# Product/Process Change Notification PCN08203

Product:	SD card reader		Part Numbers Concerned:	See list attached	
Product Manager:	Sally Luo		Issue Date:	10 Dec, 2008	
			Page(s):	1/1	
Distribution:	Active and Contract Customers

Enhanced SD Card reader to add robustness and help prevent reversed insertion

## New Version exploded view

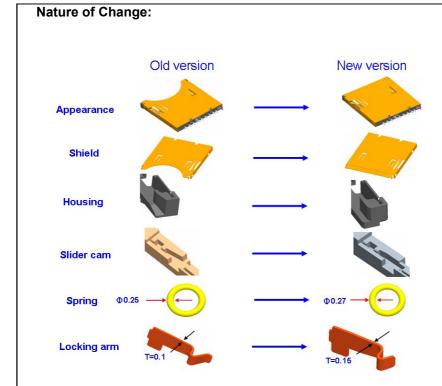
In order to prevent reversed insertion of SD cards into this SD card reader easily, the metal shield was re-designed from a "crescent" form to a "filled" form. Additional minor changes to the product design resulted into an overall more robust product.
